STATE OF NEBRASKA
DEPARTMENT OF ROADS
ADDENDUM NO. 3
AND
ELECTRONIC BIDDING SYSTEM
AMENDMENT NO. 2
PROJECT NO. STPB-77(49)
CONTROL NO. 22191
CALL NO. 250
PLATTE RIVER TRAIL, PHASE 1
LETTING DATE: NOVEMBER 8, 2012

TYP. SLAB EDGE DETAIL

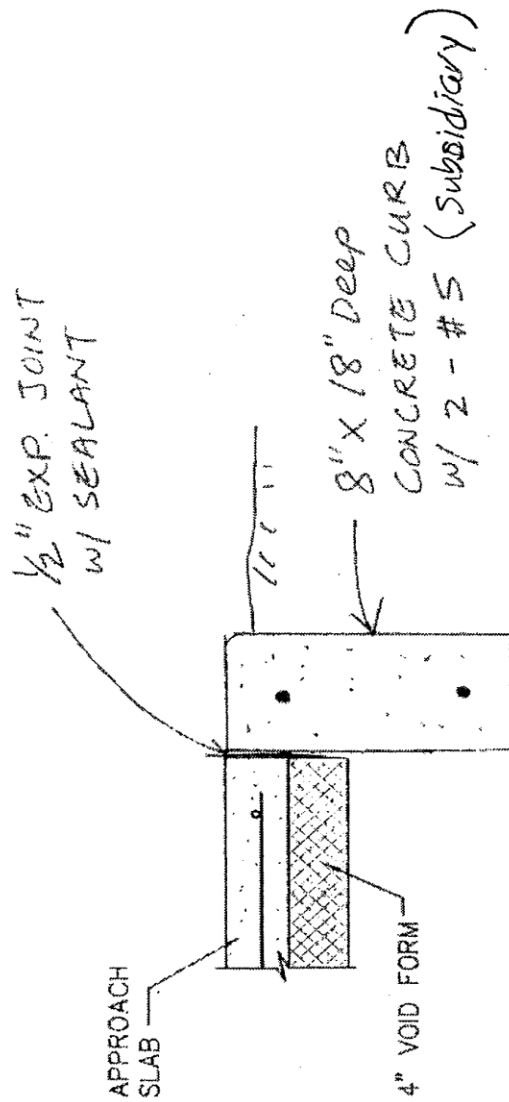
1. In the ABUTMENT NO.1 ELEVATION detail, the note "Riprap Stones Under Bridge" is void.
2. The SLAB EDGE DETAIL is void and superseded by the new detail depicted on the attached sheet.

Plan Sheet 13
(S-4)

REVISED
